Fermilab

TS-SSC 91-144
7/23/91

Subject: Outer coil wedge: symmetric or asymmetric

Figure 1

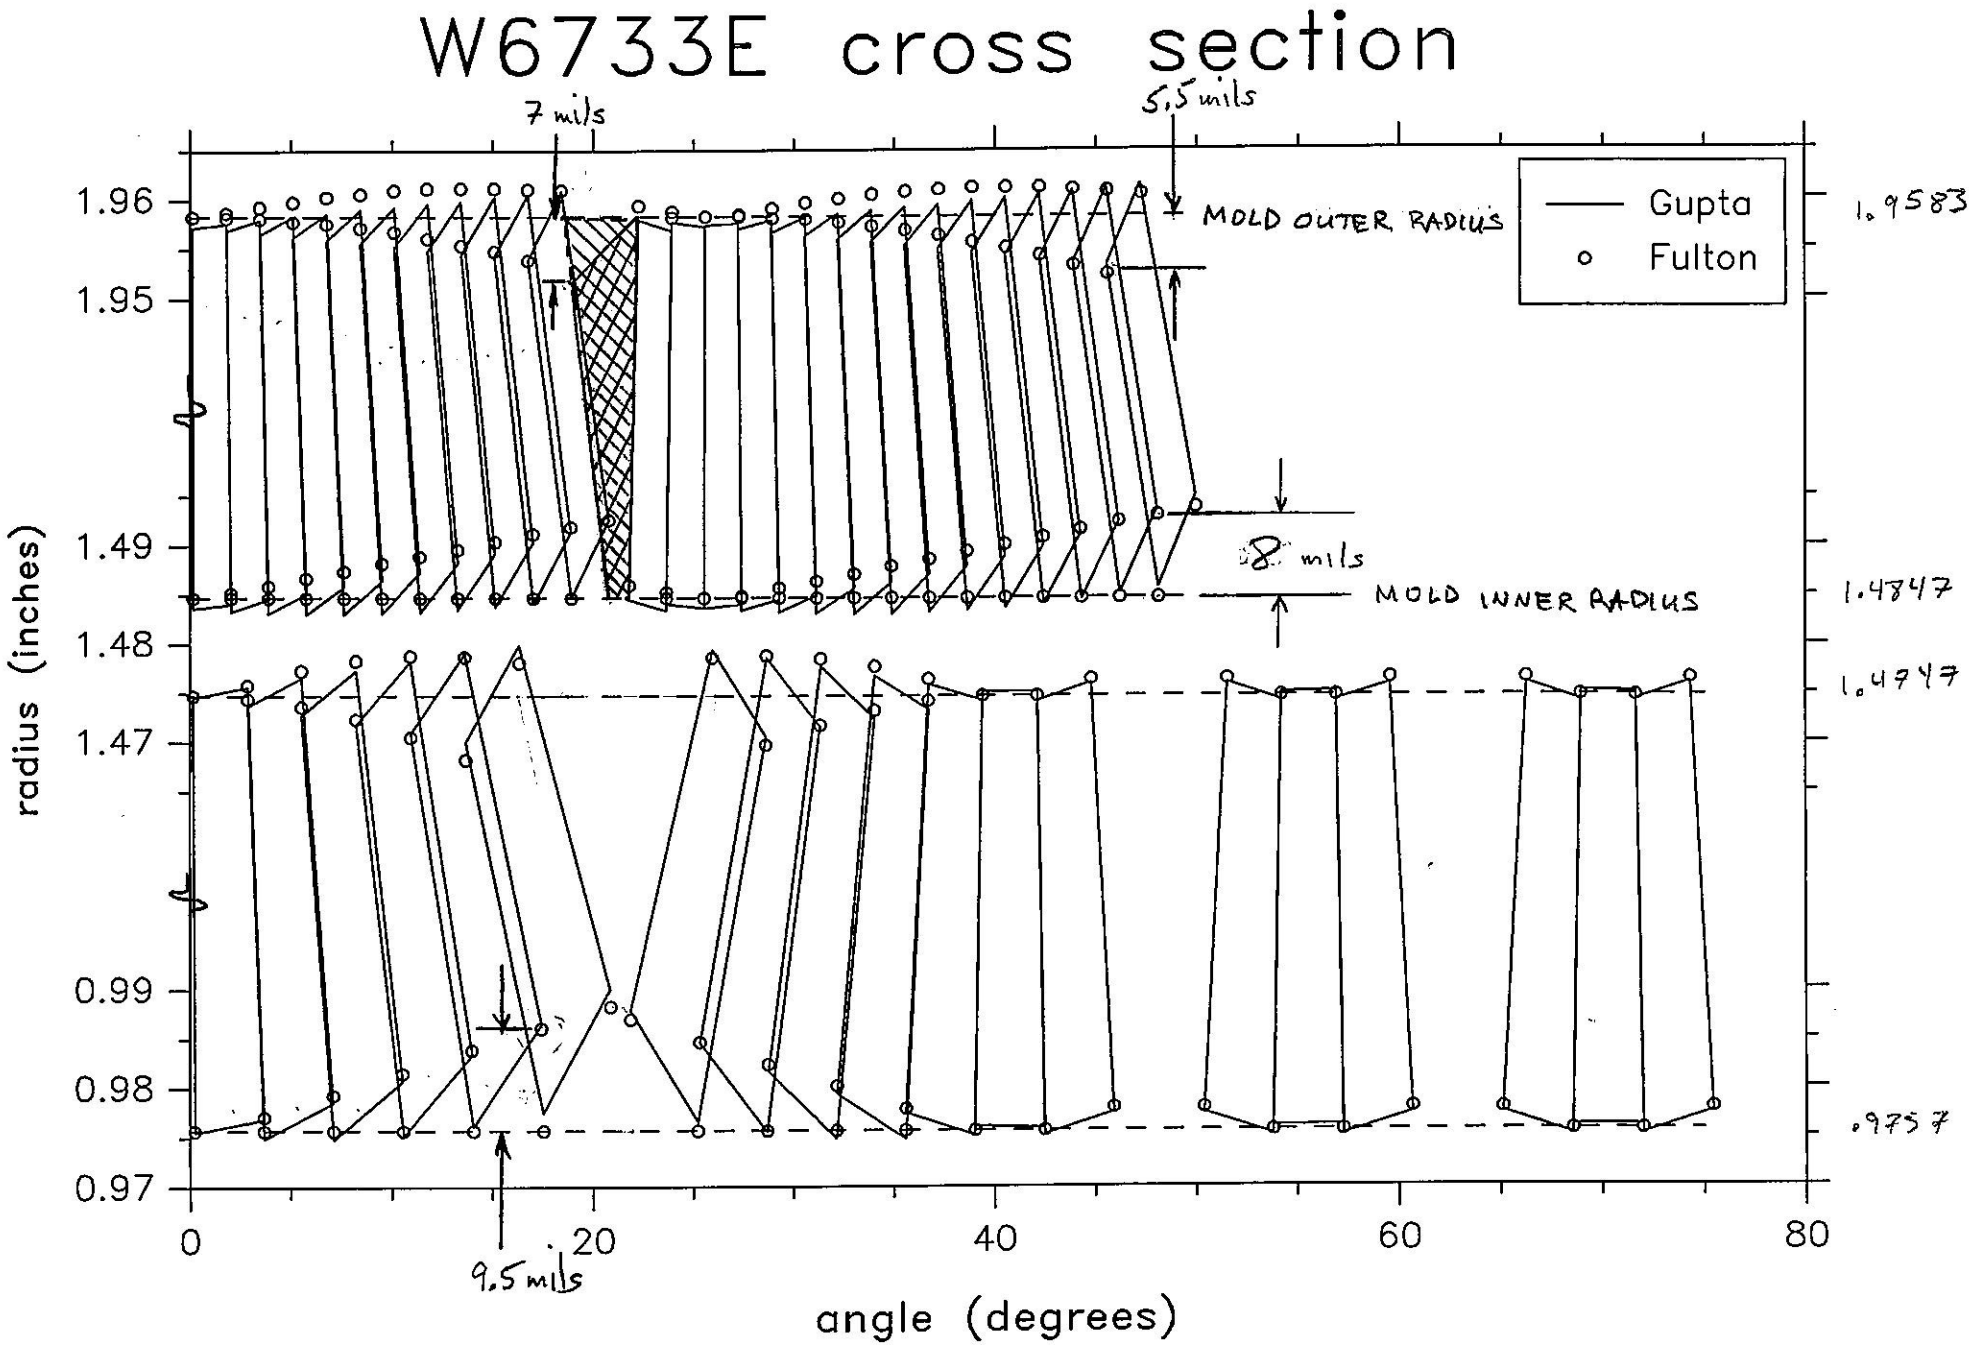
Figure 1 is a representation of the collider dipole cross section. Corners of the insulated cables are plotted in rectangular coordinates with the angle from the mid-plane along the x-axis and the radius along the y-axis. The r-axis (y-axis) is broken at two places to enhance the visibility of the cable corners. Straight lines are drawn between the corners on this highly non-linear scale which results in the apparent overlap between some pairs of adjacent cables. Two sets of coordinates were available to me in making this plot, one generated by Ramesh Gupta, which represents the "official" magnetic design and one generated by Howard Fulton, which was used for most of the mechanical design work at Fermilab. The rms deviation between the two sets of points is 0.6 mils and the maximum deviation is 2.2 mils. The dimensions quoted below are from the average of the two sets, rounded to the nearest 0.5 mil. Shown also are the inner and outer radii of the coil molds. Note that many cable corners extend outside the mold boundaries, particularly at the outer radius. This probably does not actually occur because of the non-zero radii of the cable corners which are ignored in this plot.

The asymmetric version of the outer wedge, which fills the full cavity at the outer radius, is shaded with diagonal lines and the symmetric version is cross-hatched. The symmetric wedge fails to fill the entire coil radius on the face towards the coil mid-plane leaving a 7 mil gap measured with respect to the outer mold surface. In computing this width of "unsupported" cable I have ignored the non-zero radius of the cable and wedge corners but take into account that no part of the coil can actually extend beyond the mold boundary. The point here is not to compute the exact amount of unsupported cable but to make comparisons between this point in the cross section and several others where, because the cables are far from radial, similar unsupported cable corners exist. The pole turn of the outer coil is quite far from radial (vertical on this plot) and therefore it and the adjacent cables do not fully support their neighbors. The "overhang" is approximately 8 mils at the inner radius and 5.5 mils at the outer radius. The maximum "overhang" anywhere in the cross section is 9.5 mils at the inner radius between turns 5 and 6 (counting from the mid-plane) of the inner coil. Thus corners of several cables are "unsupported" in this cross-section by amounts comparable to that which would occur if the outer coil wedge were made symmetric.

Figure 2

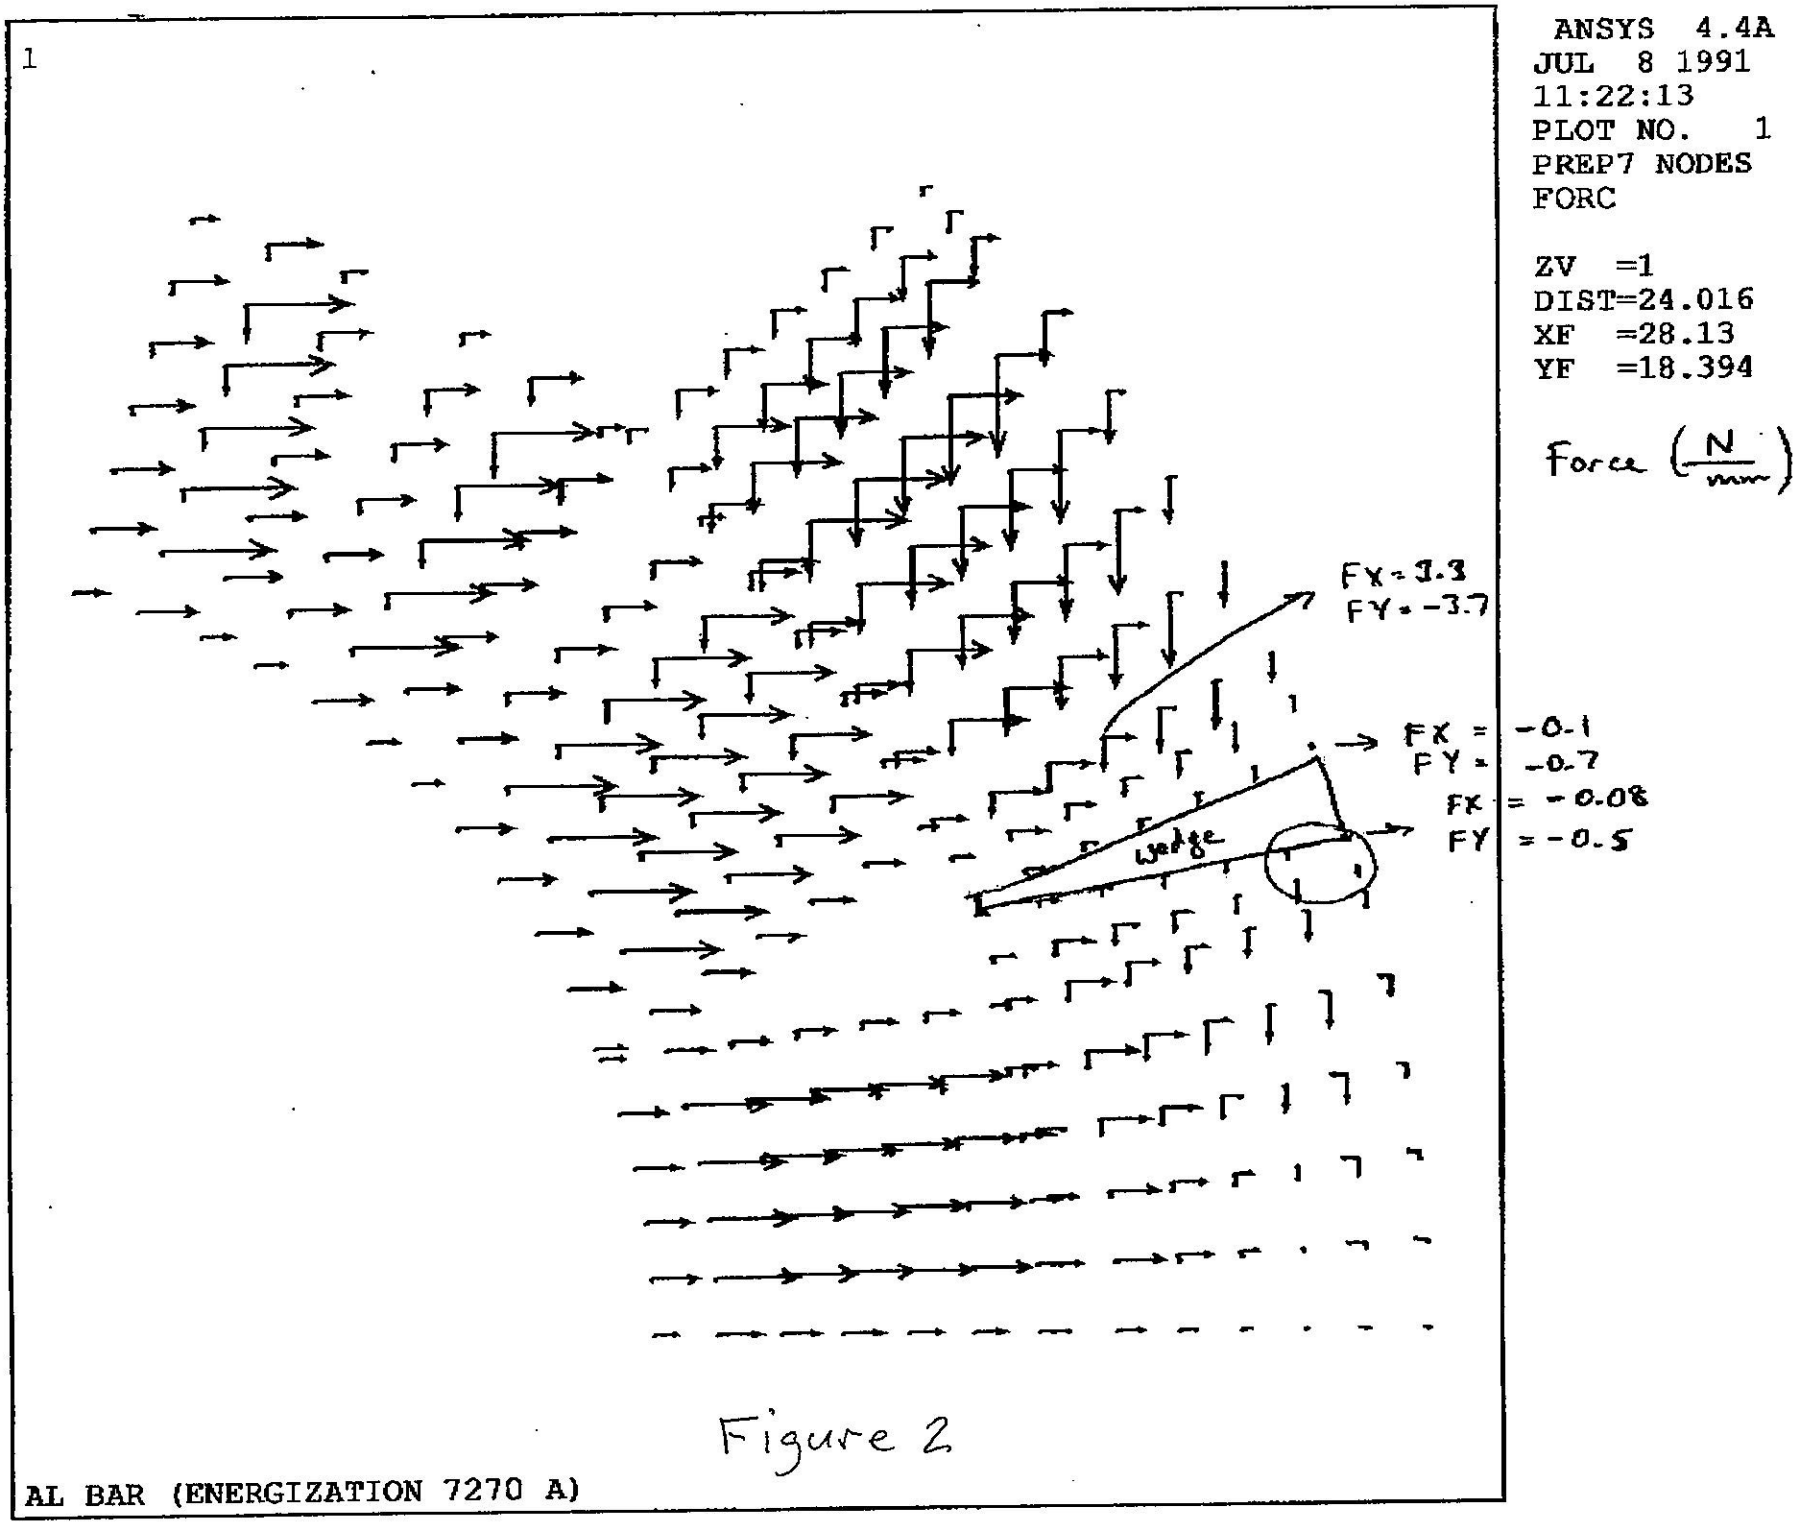
Figure 2 shows the Lorentz forces on each of the conductors at 7 radial locations. (This Figure was supplied by Bulent Aksel in a fax to Fred Nobrega dated 7/10/91.) Note that the force at the point where the cable just below the wedge would be "unsupported," the Lorentz force is almost zero and is pointed towards the mid-plane and away from the wedge. Thus the presence or absence of the 7 mils of wedge material can have little or no effect on the behavior of this cable under excitation. In contrast, the force at the inner edge of the pole

turn of the outer coil is more than 5 times larger. It is directed in the azimuthal direction, that is in the direction in which this cable corner is "unsupported" by its neighbor. Furthermore, this is at the high field point of the outer coil (where the field margin is only a few percent greater than at the pole turn of the inner coil), while the turn just below the wedge is in a much lower field region. (See Figure 3, taken from R.C. Gupta, S.A. Kahn and G.H. Morgan, SSC 50 mm Dipole Cross Section, presented at the 3rd IISSC, march 13-15, 1991, Atlanta, GA.) At the point of maximum "overhang" between inner turns 5 and 6, the Lorentz force are both considerable, but the force is essentially in the plane of the cable, so the apparent lack of support is apparently irrelevant.
